CORNERSTONE AUTO- **REVISION TO PLANS 10-10-2025**

REF ODRINANCE 22-O-51 & 22-O-52 **Note: deletion of addition negates the need for a setback variance**

SITE PLAN NARRATIVE- Reprinted from original approved site presentation- Changes in **BOLD**)

EXTERIOR ELEVATIONS

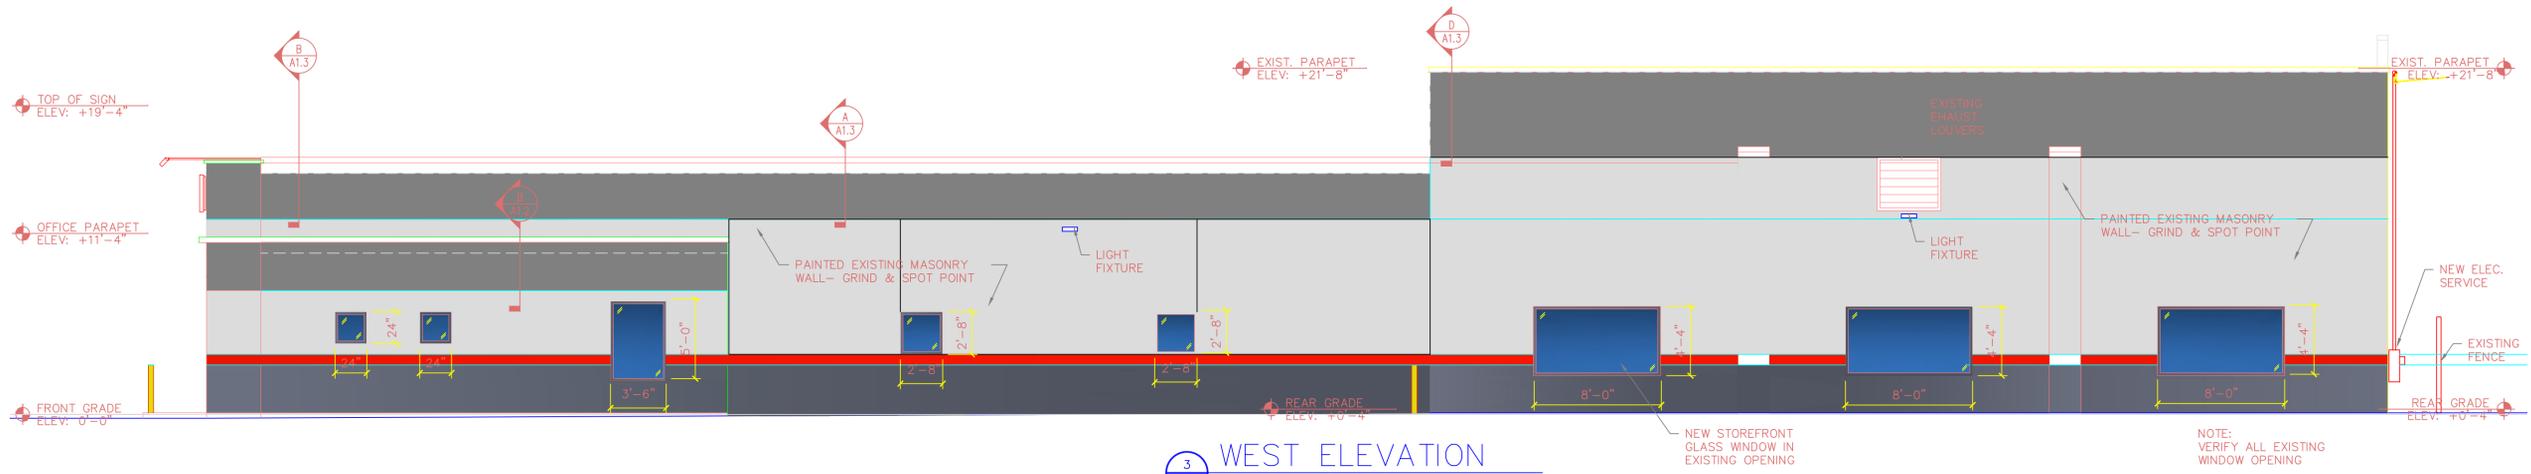
The addition on the east side has been eliminated, and the dock doors are now grade level overhead doors to match the other overhead doors. They have also decided to eliminate the metal siding at the top of the existing masonry walls. Also, the glass in the overhead doors has been reduced to 3 vision panels at eye level. The solid panels will be the same metal color, dark charcoal grey.

The Web Gray color was added to simulate the metal panels which were deleted. See elevations for location of these Sherwin Williams masonry paint colors.

**SW 7075 Web Gray
SW 7664 Steely Gray
SW 6871 Positive Red
SW 9154 Perle Noir**
